**Docket Item #7 A-E**

**Carlyle Centre  
Block 27 – Eisenhower East  
310 Hoofs Run Drive**

**Planning Commission  
December 5, 2006**

CARLYLE CENTRE (BLOCK 27)

### Attachment #3

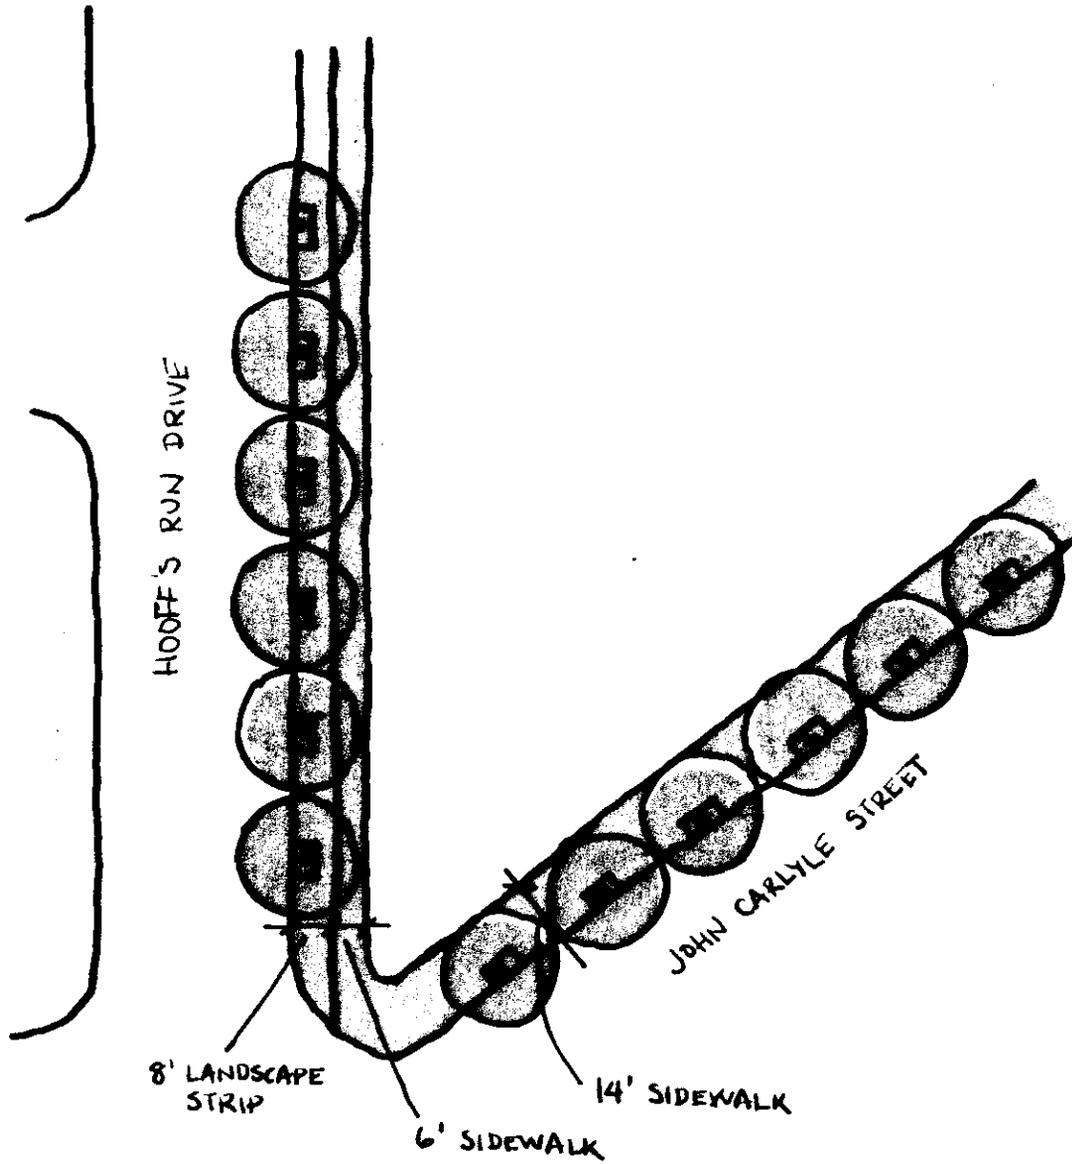
12. John Carlyle Street, Eisenhower Park Drive, Savoy Street, Bartholomew Street, and Limerick Street shall be dedicated to the City as public streets as generally depicted in *Attachment # 3*. The approved street names shall be depicted on the final site plan and subsequent documentation and plans. (P&Z)
13. The applicant shall be responsible for the street design, construction, and dedication of right-of-ways for John Carlyle Street (western street from the future Eisenhower Park Drive to the future Savoy Street), Eisenhower Park Drive (southwestern street from the future Limerick Street to the future John Carlyle Drive), Savoy Street (northern street from the future John Carlyle Drive to the future Bartholomew Street), Bartholomew
